Technical Service Bulletin

91 Rear parking aid does not work, various DTC(s) stored in the driver assist or vehicle electrical system modules

91 19 10 2057357/1 November 8, 2019.

Model(s)	Year	VIN Range	Vehicle-Specific Equipment
A6, A7	2019	All	Not Applicable

Figure 1. Location to inspect T14m for damage.

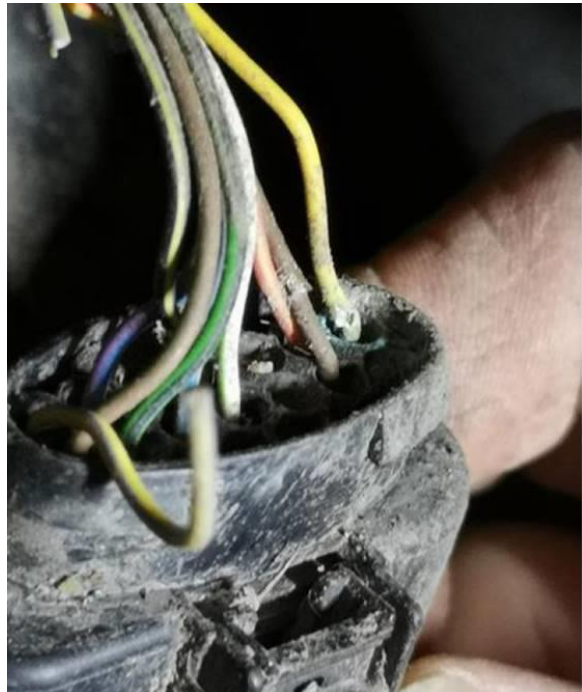
The connector housing or wires leading to connector T14m may become damaged due to road debris.

1. Inspect connector T14m and its circuitry at the left rear bumper connector station TSFHL (Figure 1 and 2).

2. If damage is found, repair the affected wires and/or connector housing using VAS1978B.
3. Slide the new grommet, part number 443 906 102 G onto the harness and then reassemble the connector. Ensure the grommet is fully seated on the connector before refitting the bumper.
4. Once the repair is complete, clear out all DTC's and check system for functionality.
